Addendum No. 08

Title: North Bay Car Shop Heating and Ventilation Upgrades

RE: Clarifications/Questions

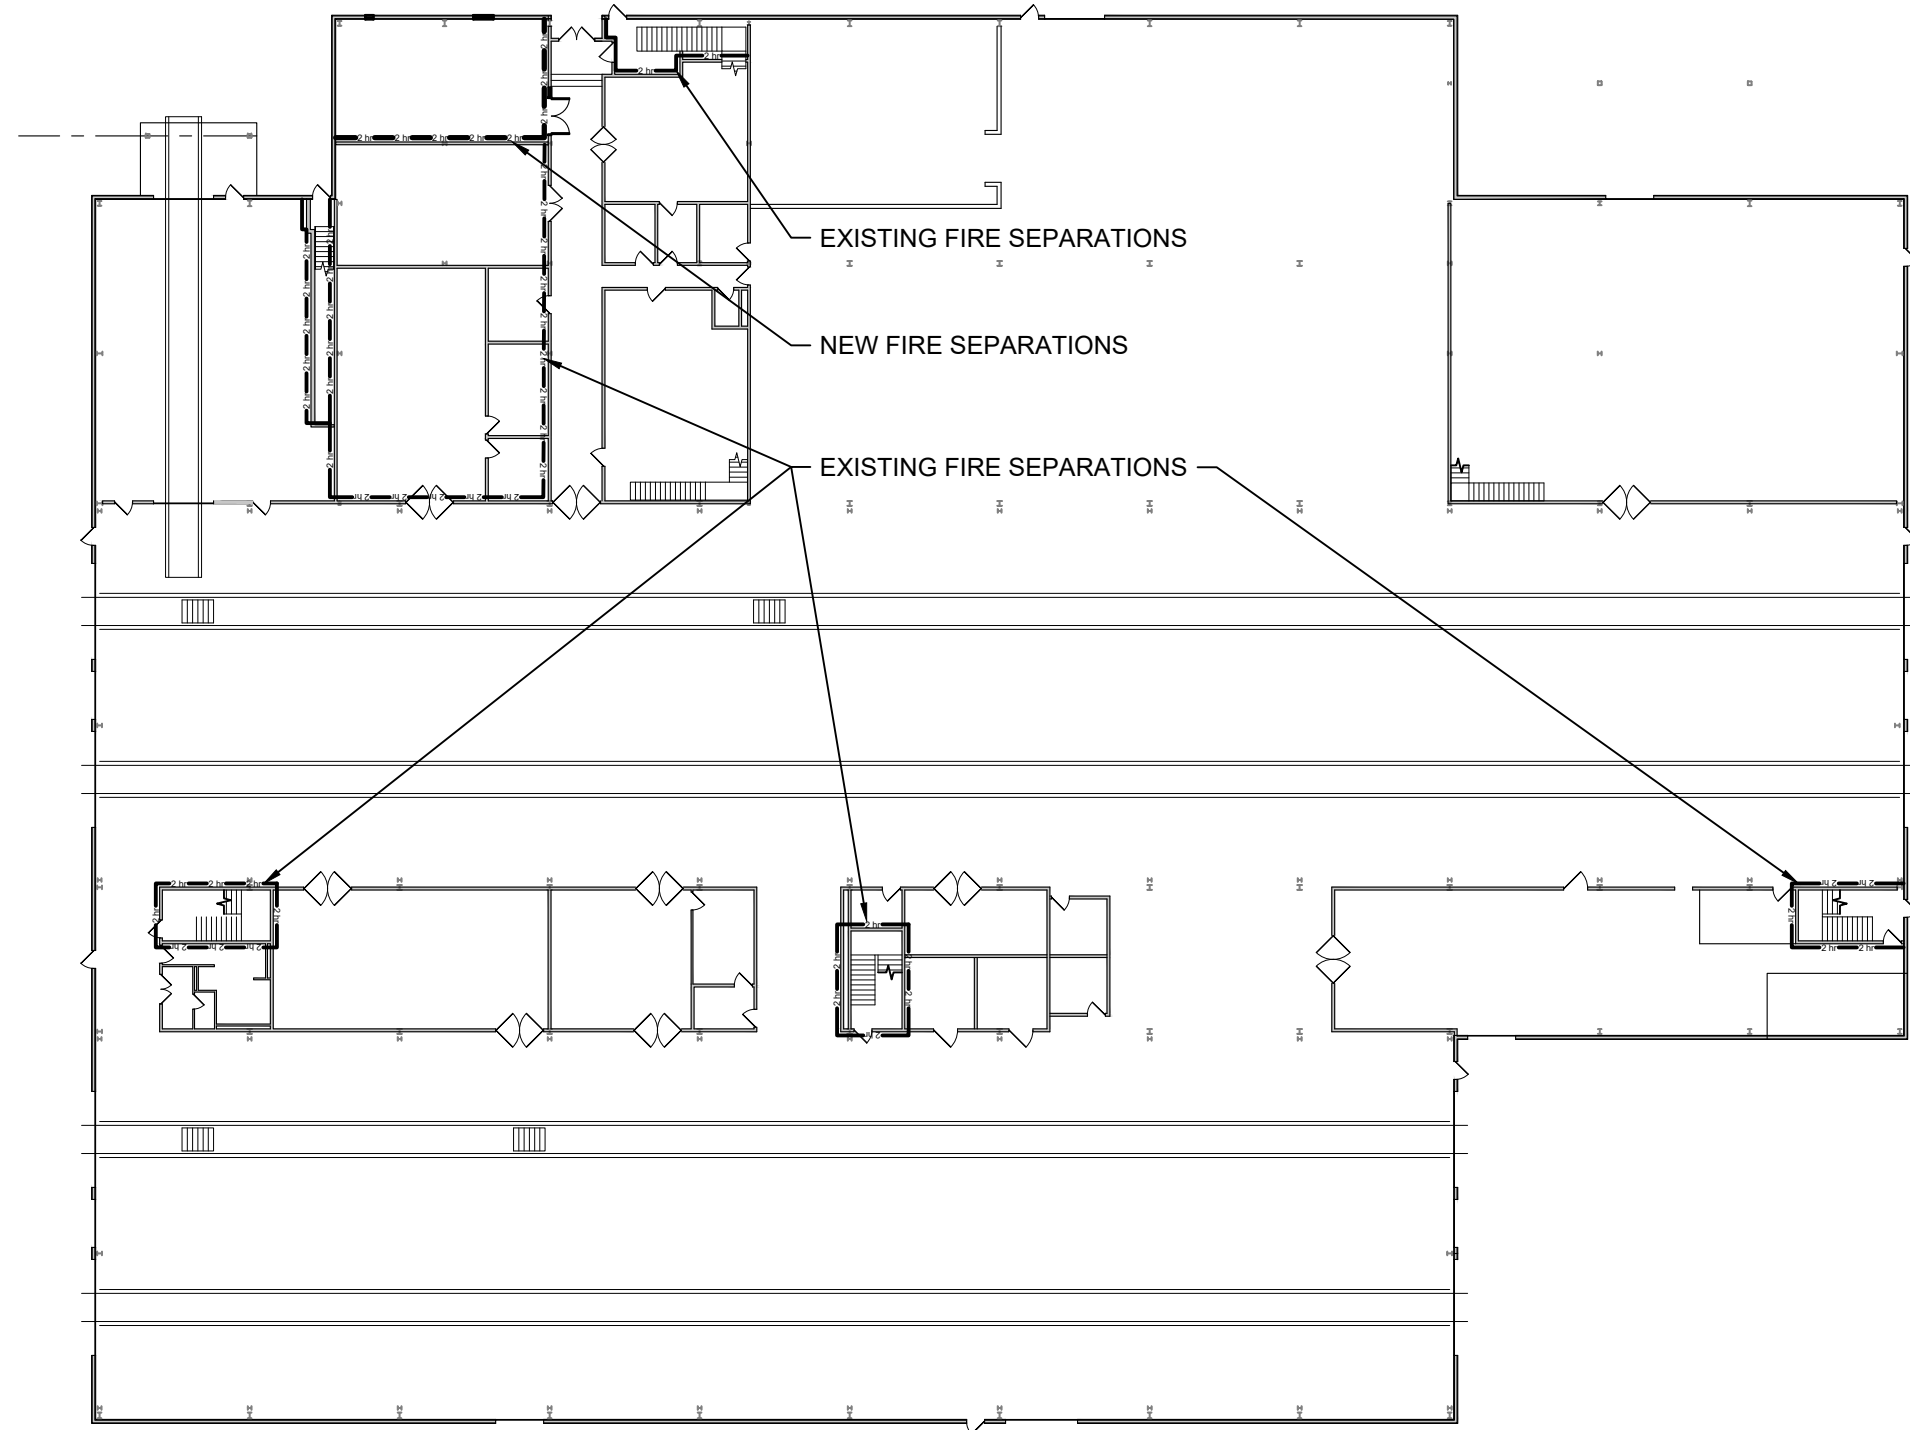
Item 10: Would ONTC please confirm if the following would be considered as an acceptable equal?

Specified Manufacturer	Equipment	Requested Manufacturer
EH Price	Grilles and Diffusers	Metalaire

Answer: Yes, ONTC advises that this would be considered as an acceptable equal.

FIRE SEPARATION PLAN

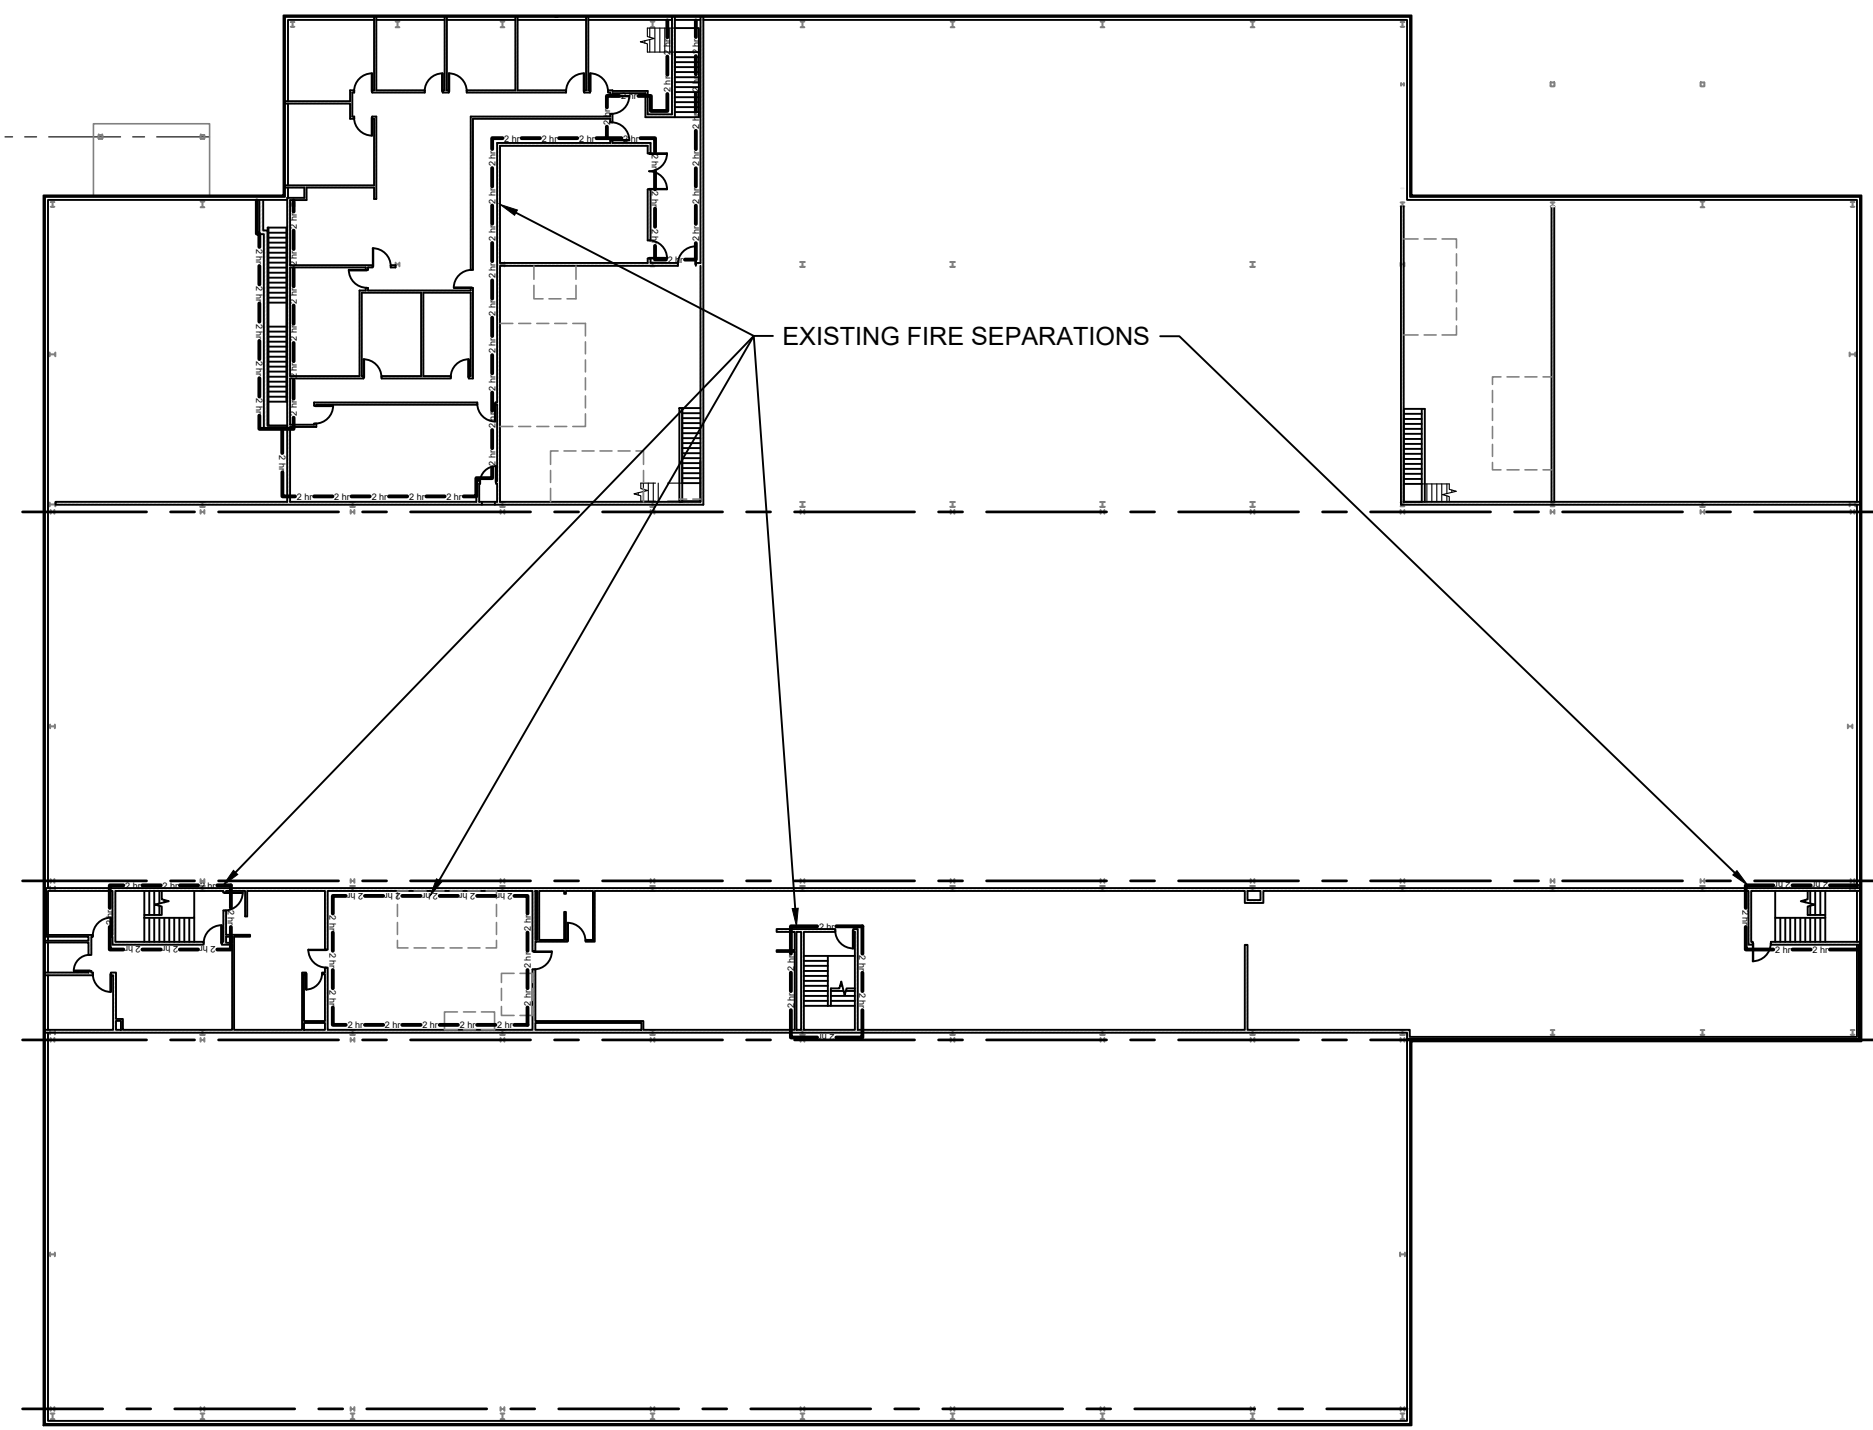
Item 5: Would ONTC please advise if the new roll-up door on grid line 14 in mechanical room 213 is required to be fire-rated? Drawing 28994-2379-A01 does not show grid line 14 as a fire separation, but drawing 28994-2379-M15 shows fire dampers on grid line 14 in all ductwork. The current specification for the 10x10 CLOPAY model 157C is not fire-rated. Please confirm.

Answer: Please see attached revised Fire Separation Plan, attached to this Addendum No. 08. ONTC advises that the following shall be considered in reviewing the revised Fire Separation Plan:

1. Remove 1-HR FRR at Wood Mill B&B 128 and Mechanical Room 213.
2. Add Existing 2-HR FRR at Mechanical Room 206.
